## REPORT

Report Date: June 21, 2022  
Contact: Theresa O'Donnell  
Contact No.: 88434  
RTS No.: 15201  
VanRIMS No.: 08-2000-20  
Meeting Date: July 5, 2022  
[Submit comments to Council](#)

SUBJECT: Policy and Directions – Application for Rezoning at 830-850 Thurlow Street and 1045 Haro Street

**Figure 6: Public View 3 (Queen Elizabeth Park)**

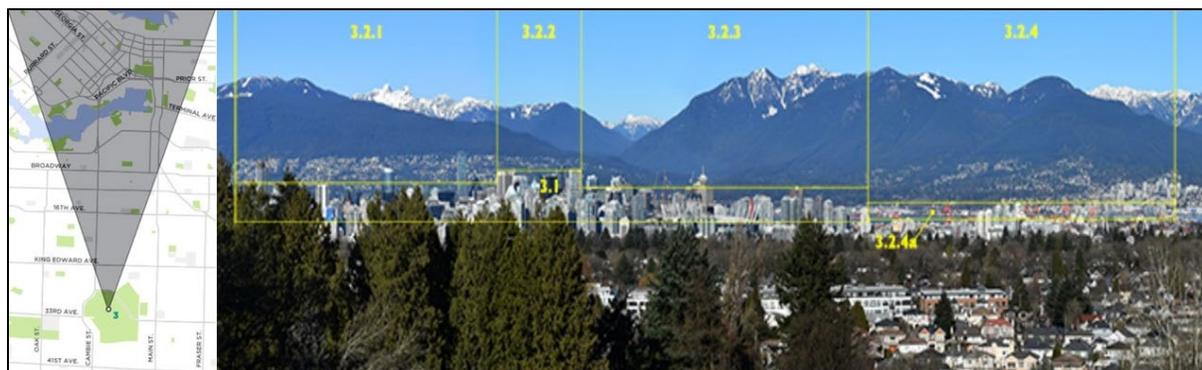
Council-approved protected public view D (Heather Bay), originating at Leg-in-Boot Square secures views to the Lions and Brunswick Mountains (see Figure 5). As noted above, the majority of this site is limited by the Heather Bay view cone D. A small area of the southwest corner of the property is not covered by the Heather Bay view cone, and in theory could

penetrate the QE view cone (see Figure 6), however that area is too small to develop (see Figure 6 & 8).

**Figure 7: Intrusion into View Cone**

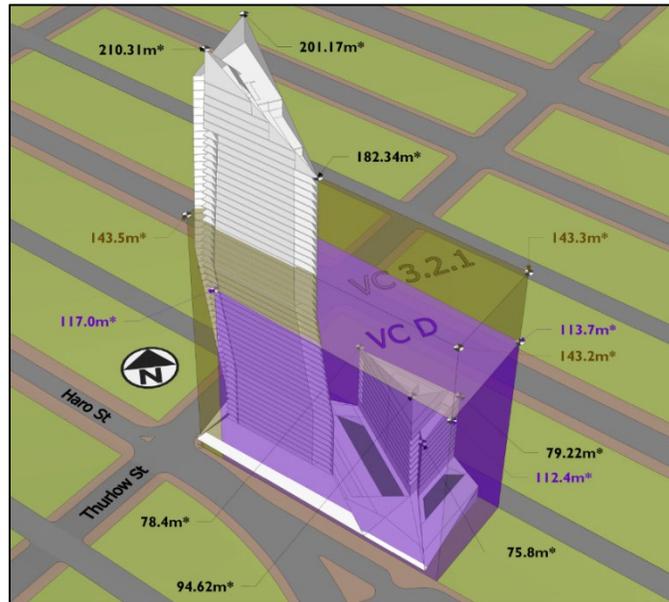
While there are a number of height directives applicable to this proposal, as detailed below and in the Policy Context section of this report, staff note that the proposed height is broadly non-compliant with Council-approved policies. By proposing intrusions into protected view corridors, the proposal varies significantly from what would otherwise be anticipated at this location (see Figure 7). At its most restrictive point, public view D limits the site to a height of approximately 79.2 m (260 ft.).

As stipulated in the *Guidelines*, the maximum building height calculated for view protection includes all appurtenances such as mechanical penthouses, decorative roofs, and aerials. The *Guidelines* make no provision for a structure to compromise the protected view. In very rare instances, exceptions may be considered where it can be conclusively demonstrated that any incursion into a protected view is wholly obstructed by a pre-existing incursion caused by another building. This is referred to as a “view shadow”. There are no existing buildings in this area that would place this site behind, and in the view shadow created by another building.

**Figure 9: Shadow Impacts on the 1000 and 1100 Blocks of Robson Street during the Spring Equinox (Robson Street Outlined in Red)**

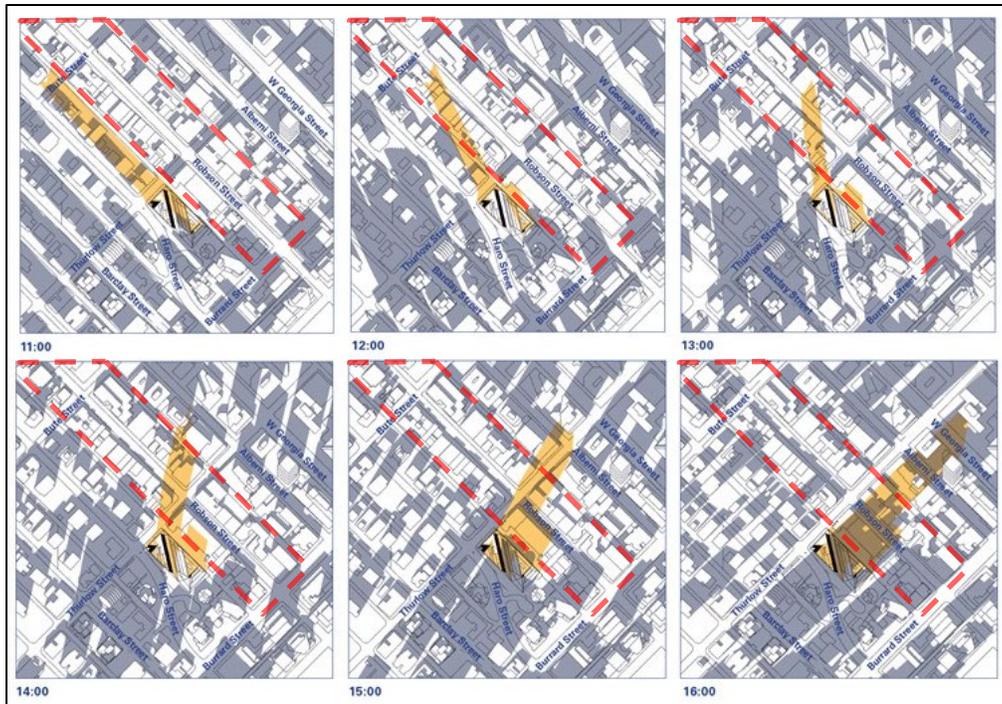
The combination of additional height and density is excess of what is anticipated under the *West End Community Plan* at the rezoning site results in contravention of solar access requirements outlined in the *Bulletin*. Whereas the *Bulletin* anticipates limited shadowing of the north sidewalk of Robson Street caused by new development between 10 am to 4 pm (10 am to 3 pm for the 1000 block of Robson Street) at the spring and fall equinoxes, this proposal contributes significant new shadowing between 12 pm to 4 pm, and the 1000 block between 2 pm and 3 pm (Figure 9).
